## CHEMICALS & PLASTICS INC.

July 19, 1982

Re: Mail Control No. 11607

The following is in reply to your letter of July 9, 1982, requesting additional information:

CHART SEALED  
SOURCE

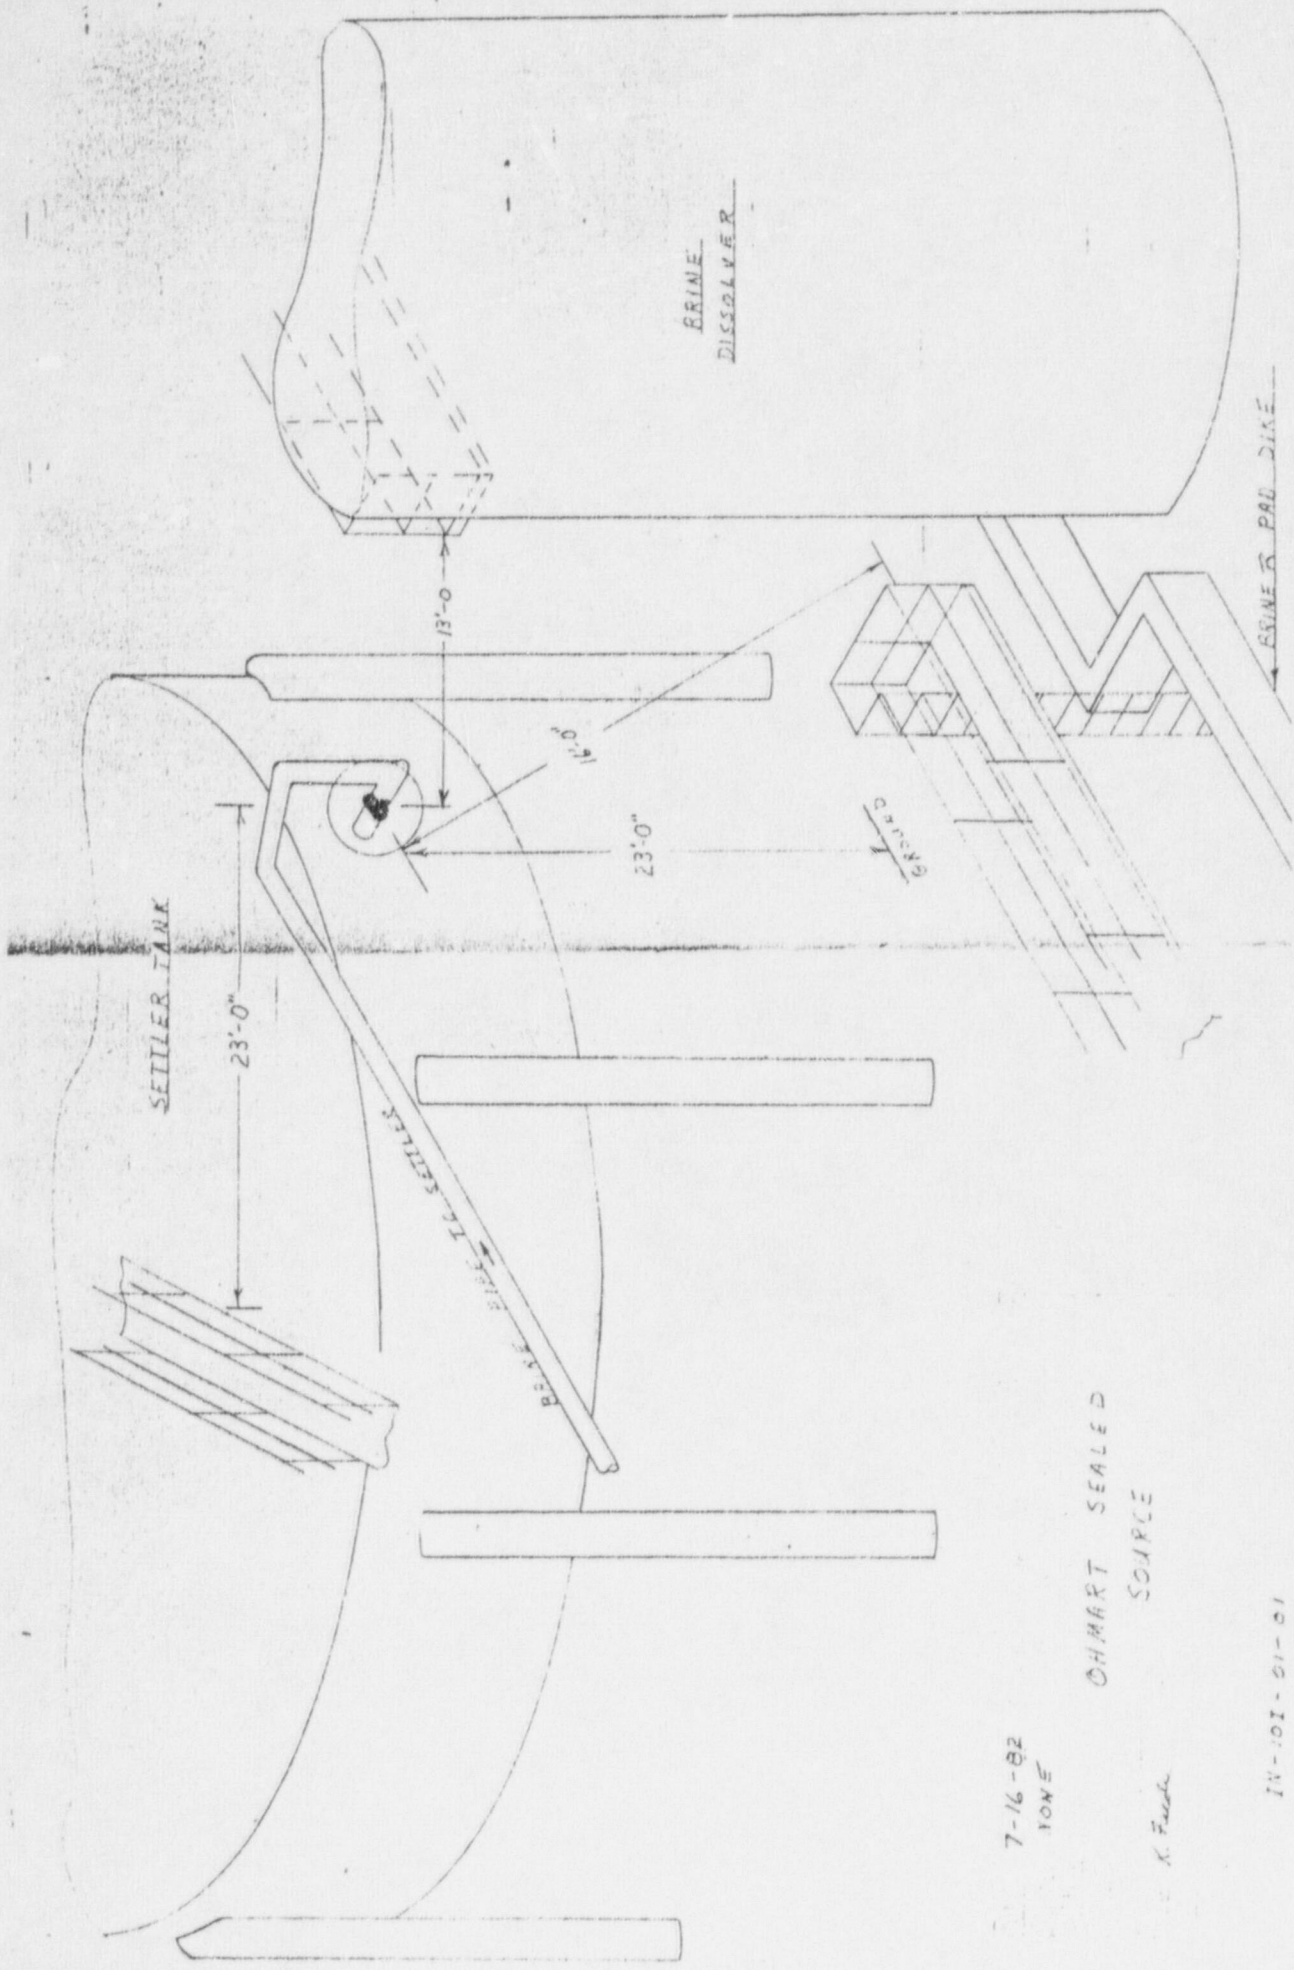
Item 13 - Description of facilities and equipment

Item 15 (b) - Means of controlling access to the device.

The source is part of an Ohmart density measuring device which is used for measurement of potassium chloride brine specific gravity. The unit is mounted on an 8 inch brine line in an area remote from working areas of the plant. Attached is a drawing showing the location of the source.

The device is in a remote and inaccessible location (see attached drawing). Access to the device requires the use of a man-lift. In addition, warning signs are posted in the immediate area of the device.
